Swiss Army Knife Rev A PCB Corrections

In production of Rev A PCBs, one row of pins (20 to 38) on the ESP32 socket was reversed. The tracks from Relay 2 to the front panel connector were also reversed.

Rev B boards are not affected.

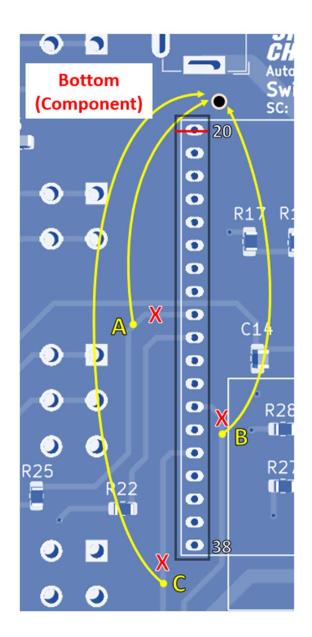
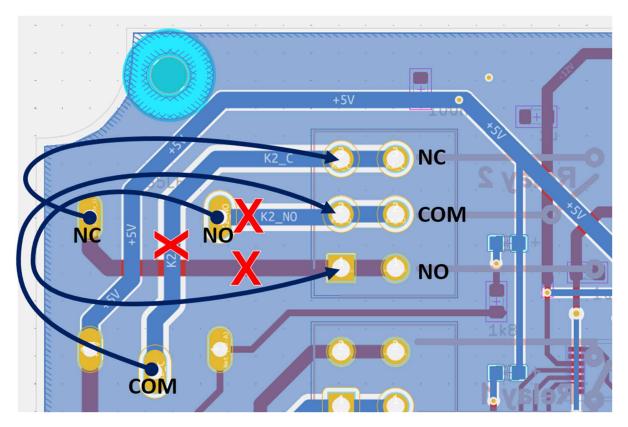
3) Cut the copper of all the tracks leading to the inner row of the ESP32 socket at the points marked X in the diagrams.

There are two on the silkscreen side, and three on the rear.

On the silkscreen side, the cuts should be made as close to the socket as possible to avoid visibility when the PCB is mounted in the case.

Cut the traces at the X marks and connect wires at A, B & C which pass through a small hole drilled between pin 20 and the power socket.

Cut the ESP32 socket at pin 20 and remove the pin.

Cut traces at the X marks and rewire SDA and SCL on the silkscreen side of the PCB, keeping the wires away from the centre of the board.

Connect the wires from the other side of the board to the ESP32 socket pins at A, B & C.

Remove the pin from the socket at pin 20.

Connect pins 32 and 38 to GND.

Rewiring pins 20-38 of the socket is the most straightforward means of rectifying the problem.

1) Remove the top left (GND) pin 20 from the ESP32 socket OR, on the ESP32, cut off the CLK pin.

Rewire all five signals to the correct pins, using fine hook-up or wire-wrap wire.

4) Connect pins 32 and 38 (ESP32 GND2 and GND3) to the ground plane.
